# M42 Junction 6 Development Consent Order

Scheme Number TR010027

## 8.6 Responses to Examining Authority's First Round of Written Questions

**Response to ExA's First Round of Written Questions**

**OM Do-Minimum scenario 2041 PM peak hour screenshot – with annotation (see Figure 4a in Appendix B)**

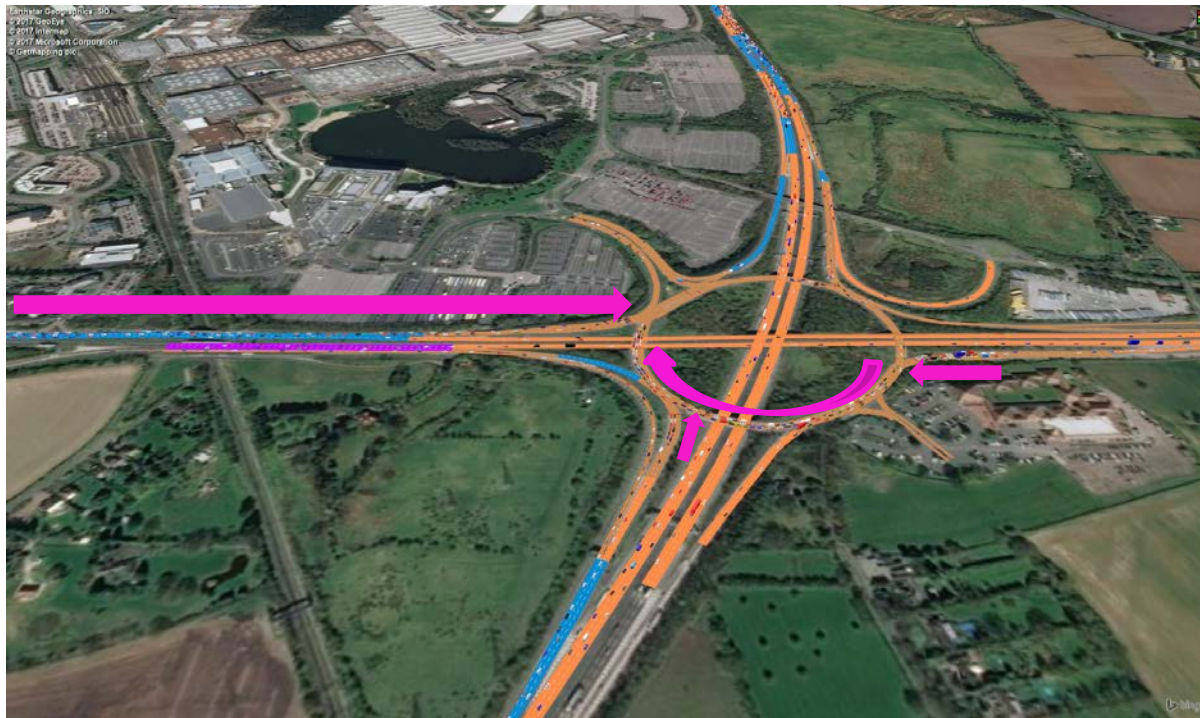
1.11.15	Applicant	<p><b>Question:</b></p> <p><b>If the answer to Q1.11.14 is 'yes', please identify the consequences, particularly regarding the occurrence of congestion and delay. Is it possible to reproduce Figure 6.3 in the TA [APP-174] for the 'do-minimum' scenario in 2041?</b></p> <hr/> <p><b>Answer:</b></p> <p>The answer to Q1.11.14 is 'yes'. The M42 Junction 6 Operational Model (VISSIM) has been run to demonstrate the 2041 'Do Minimum' PM peak scenario. The output is summarised below.</p>

The equivalent of Figure 6.3 has been reproduced for the Do-Minimum 2041 scenario with annotation to illustrate the forecast queues in the PM peak hour which are:

- A45 eastbound approach to J6 showing queues extending back from the gyratory along the A45 to Clock Interchange; and
- M42 northbound off-slip showing queues extending back from the gyratory along the off-slip to the

**Reproduced Figure 6.3: OM PM peak hour screenshot – with annotation (see Figure 5a in Appendix B)**

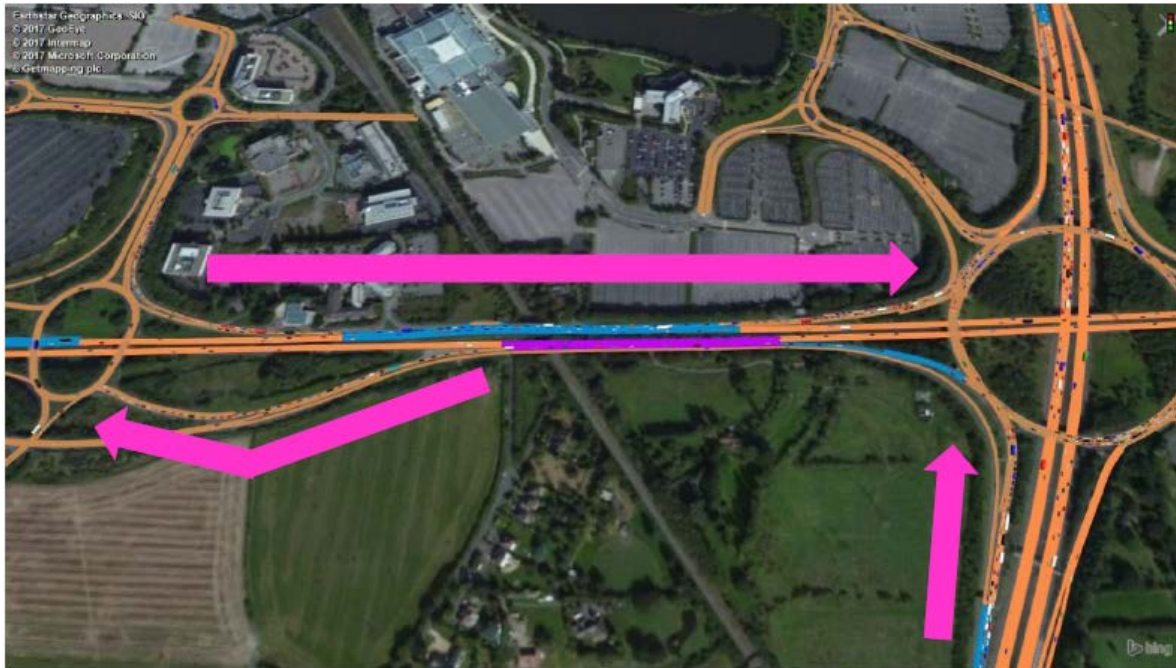
1.11.17	Applicant	<p><b>Question:</b></p> <p><b>At first glance the pattern of congestion shown in Figures 6.3 and 7.8 of the TA [APP-174] appear remarkably similar. Is it the case that the pattern of congestion at junction 6 remains similar before and after the implementation of the scheme, even though, presumably, the network will be accommodating traffic growth of 34%? How else can the Figures be interpreted?</b></p> <p><b>Answer:</b></p> <p>No. The figures are different.</p>

Figure 6.3 has been reproduced below with annotation to demonstrate the existing queues in the PM peak hour which are:

- At Junction 6 - A45 eastbound approach to J6 showing queues extending back from the gyratory along the A45 to Clock Interchange;
- At Junction 6 - M42 northbound off-slip showing queues extending back from the gyratory along the off-slip to the motorway mainline; and
- At Clock Interchange – A45 westbound showing queues extending back from the roundabout to the A45 westbound mainline.

Figure 6

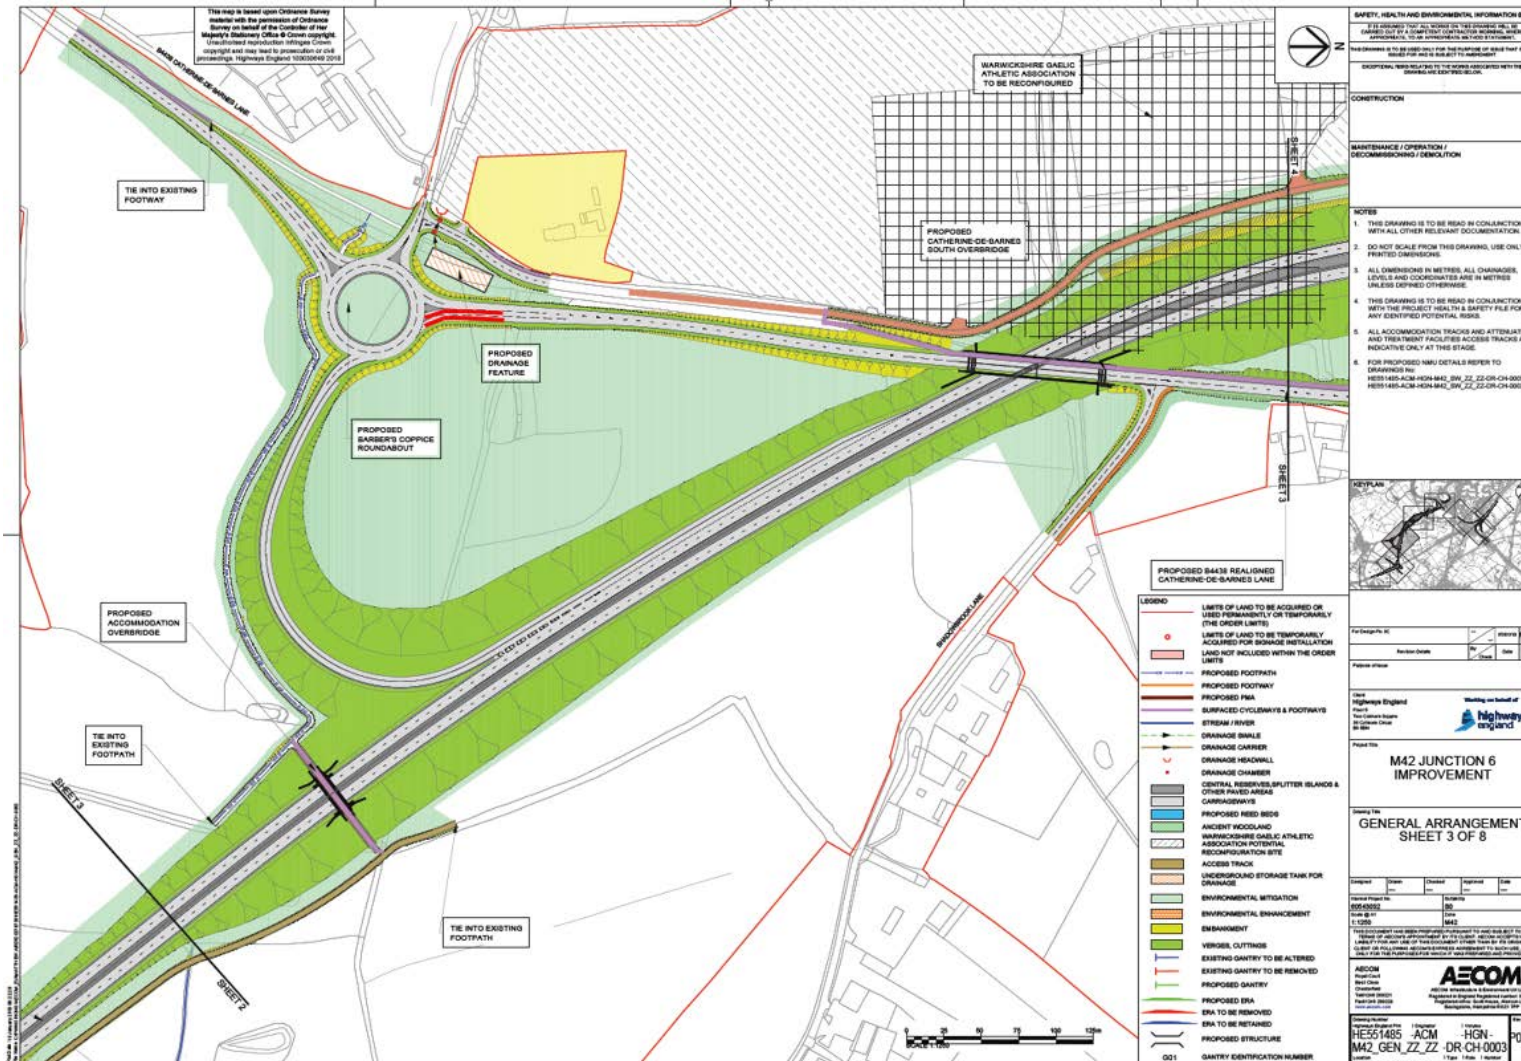
1.11.20	The Applicant, SMBC, WCC, Birmingham Dogs Home, and Mr Phillip O'Reilly	<p><b>Question:</b></p> <p><b>Please indicate the length of the 13-car queue referred to in Q1.11.19 and modelled in TA table 7.11 [APP-174] on a plan.</b></p> <p><b>Answer:</b></p> <p>The 13-car queue is forecast on the approach from the north which has two-lanes. This would result in around 7 cars queuing in each lane. With the length of a car assumed to be around 6 metres, the queue would extend to around 42 metres in both lanes, as highlighted in red in the figure below <b>(see Figure 6 in Appendix B)</b>.</p>
